ARCHITECTURAL REVIEW COMMISSION AGENDA

June 27, 2019

To: Architectural Review Commission (ARC)
From: Matt Taylor, Senior Planner
Date: June 27, 2019
Subject: SPL-19-008; Speedway Gas Station Signs, 1344 E. Fort Union Blvd.

To: Architectural Review Commission
From: Andy Hulka, Associate Planner
Date: June 27, 2019
Subject: SPL-19-003 – 6890 S. Highland Dr. – KFC

Front Elevation (East)

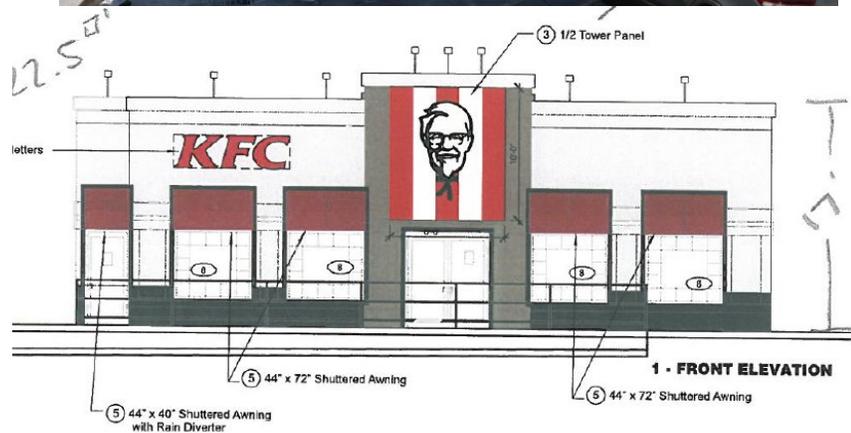
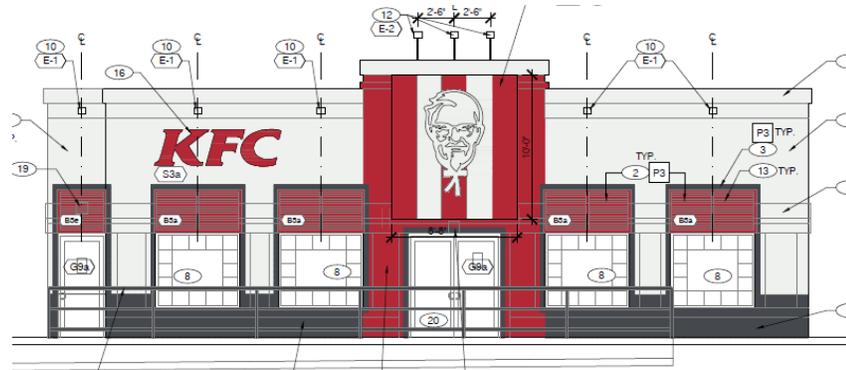
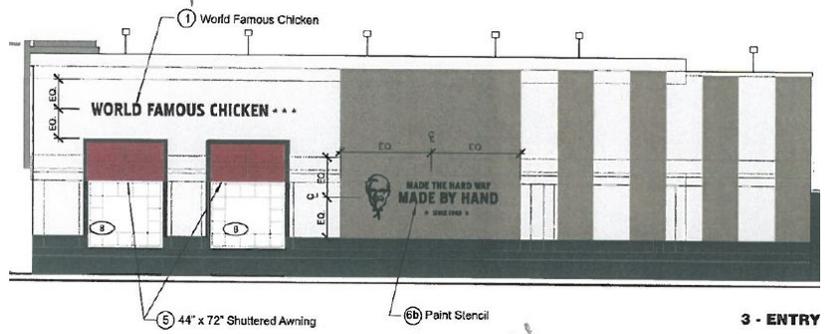
The March 2019 ARC approval required the signage above the entrance to encompass the doors and continue to the base as a single element. The revised plans have retained the half panel entry sign. The applicant sent the following explanation for their inability to meet the ARC's initial condition of approval:

The gooseneck lights above the main entrance were kept for the new design and the other gooseneck lights have been replaced with new exterior light fixtures that do not extend above the roof. No changes have been proposed to remove the guardrail or otherwise redesign the front entry.

"We cannot conform to the architectural review attached which requests we put a full panel at this location. The full panel would cover our ADA entrance which is not in compliance with ADA standards. We cannot put any panels down the sides of the doors as this would not be approved under the National branding standards of KFC. Please find attached picture of a KFC Corporate approved half tower panel."

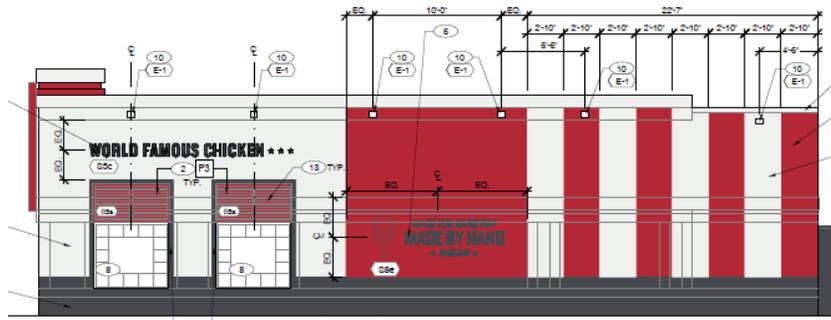
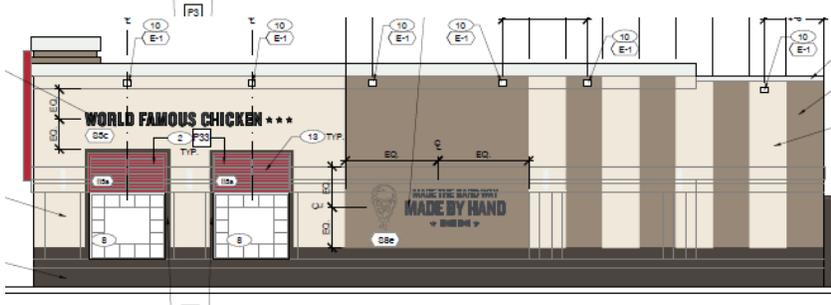
The revised plans on the north side include new exterior light fixtures that do not extend above the roof and a tan/brown paint color scheme.

Side Elevation (South, Drive-Thru)

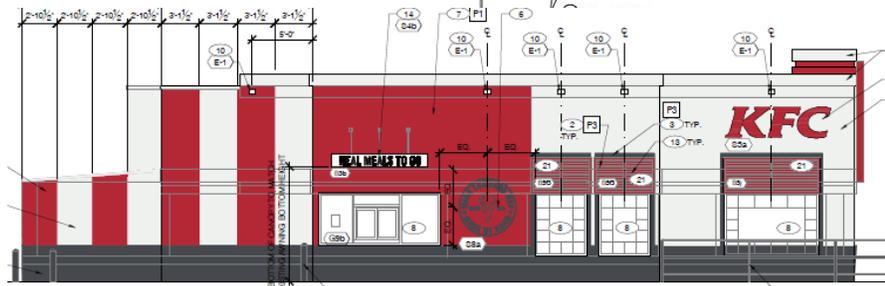
The south side has also been revised to include new exterior light fixtures that do not extend above the roof and a brown/tan paint color scheme.

Rear Elevation (West)
Existing

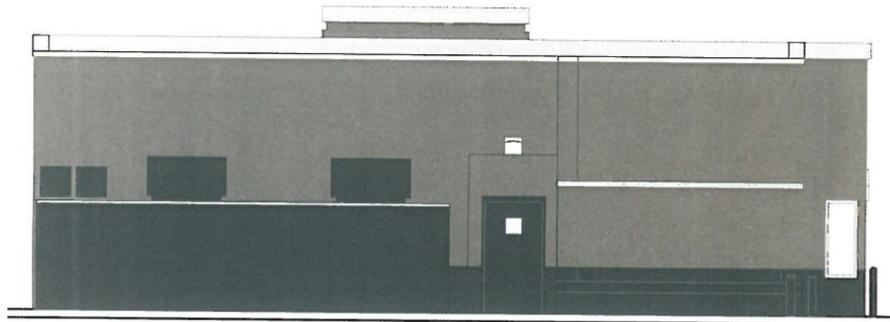
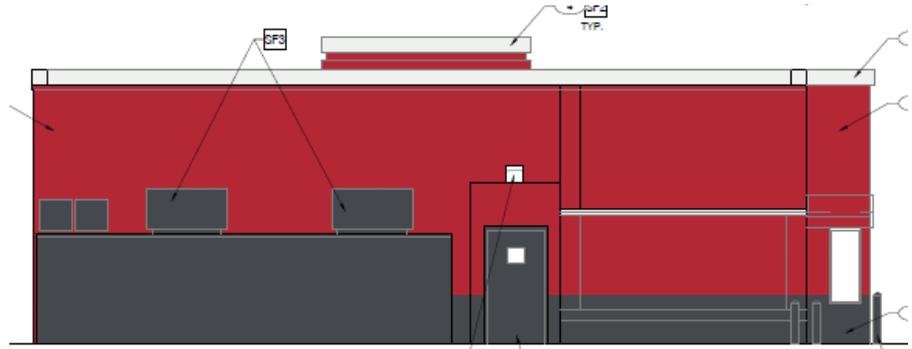
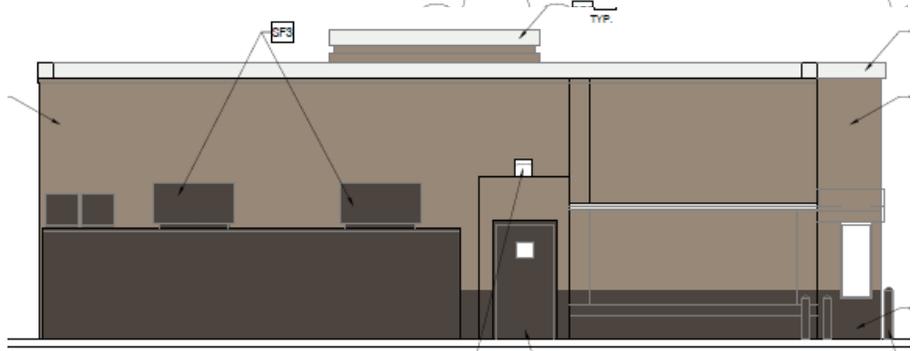
The west wall is now proposed to be painted almost entirely brown.

Design Guideline 17.2 and 17.6: Crosswalks Should be Distinctly Marked for Pedestrians, and Constructed Out of Different Hard Material than the Rest of the Street, Include Trees Along Pedestrian Walkways Where Possible.

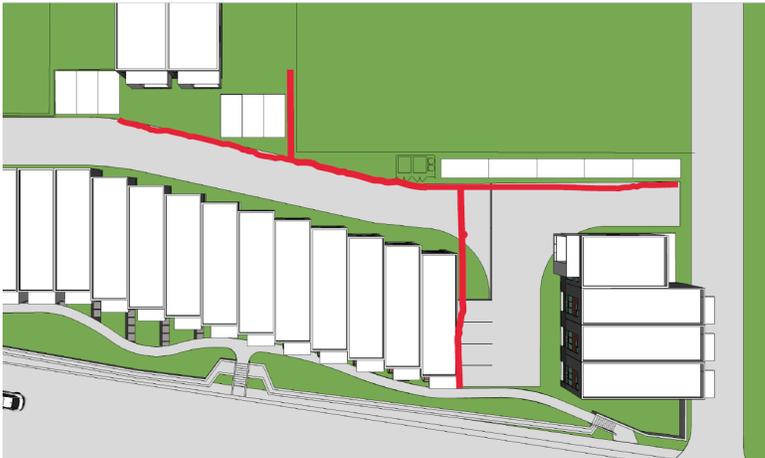
Recommendation: Staff does not have specific recommendations on how this space is developed, but ask the ARC to pay careful attention the design of this area. As for the lack of trees, perhaps some columnar trees close to the building and out of the setback provisions of the adjacent power lines could be considered.

Design Guidelines 17.3, 17.14, 17.15, 17.17, 17.18, 17.19: Landscape and Streetscape

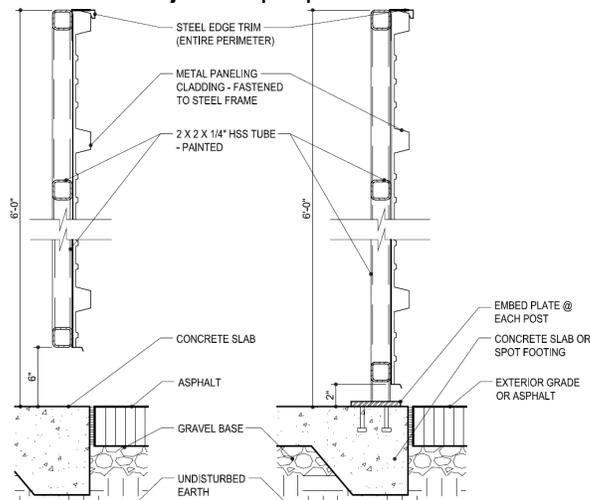
Commentary: The site landscaping plan is not specific enough to determined compliance with the above design standards.

Recommendation: Staff recommends that a detailed landscaping plan be submitting showing substantial compliance with all landscape design standards for review and approval by the ARC>

Additional Detail and Modifications Required to Site Plan

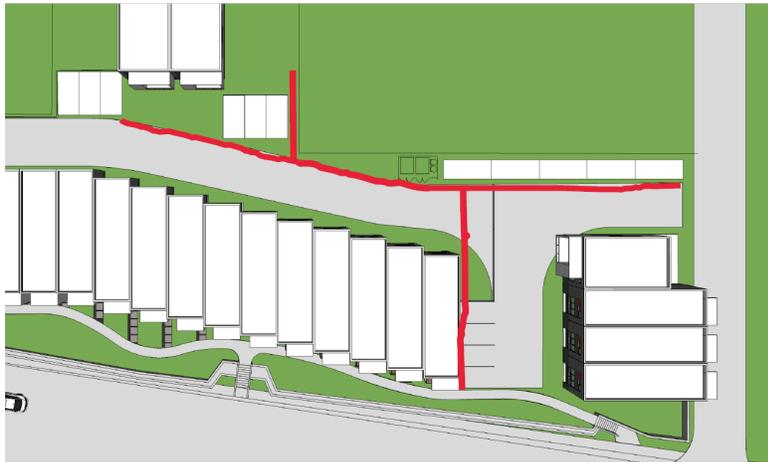
Please provide preliminary retaining wall details per 19.76.050.E

Please modify retaining wall plans to comply with the above clear view standards.
